Access Compliance Report

Public Rights-of-Way

Intersection ID: 9923	Main Street: BEDFORD_GREEN_LN	Cross Street: FINDON_PL	Location:	N
ADA ID: C85B634B6A0B	Ramp Type: Perp	Initial Pass/Fail: Fail	Overall Compliance: No	Severity Score: 10
Codes/Mitigation Info/Possible Solution		Field Measurements/Component Compliance

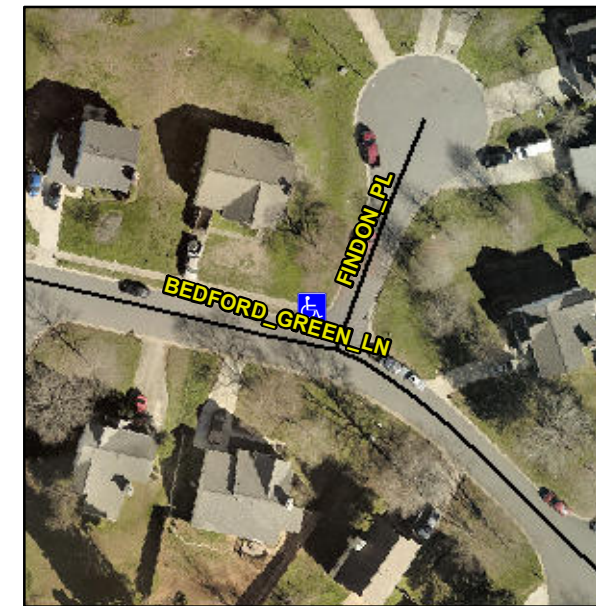
R304.5.1, R304.5.3

Compliance	Description	Data	Compliance	Description	Data
N/A	Ramp Length (in)	57.0	Yes	Ramp Slope (%)	6.4
No	Ramp Width (in)	42.0	No	Ramp XSlope (%)	4.8
N/A	Flare Type LT	N/A	N/A	Flare Type RT	N/A
N/A	Flare Slope LT (%)	N/A	N/A	Flare Slope RT (%)	N/A
N/A	Flare Traversable LT?	N/A	N/A	Flare Traversable RT?	N/A
N/A	Landing Length (in)	N/A	N/A	DWS Provided?	N/A
N/A	Landing Width (in)	N/A	N/A	DWS Contrast?	N/A
N/A	Landing Slope (%)	N/A	N/A	DWS Length (in)	N/A
N/A	Landing X Slope (%)	N/A	N/A	DWS Full Width?	N/A
N/A	Landing Curb? (Y/N)	N/A	N/A	DWS Offset (in)	N/A
N/A	Shared Landing?	N/A			
N/A	Gutter Ponding?	N/A	N/A	Gutter Slope (%)	N/A
N/A	Gutter Lip Ht (in)	N/A	N/A	Gutter X Slope (%)	N/A
N/A	Painted X Walk1?	No	N/A	Painted X Walk2?	N/A
	X Walk 1 Direction	To SE		X Walk 2 Direction	N/A
N/A	X Walk 1 Width (in)	N/A	N/A	X Walk 2 Width (in)	N/A
	X Walk 1 Slope (%)	4.9		X Walk 2 Slope (%)	N/A
	X Walk 1 X Slope (%)	0.0		X Walk 2 X Slope (%)	N/A

Remove & Replace Entire Ramp.
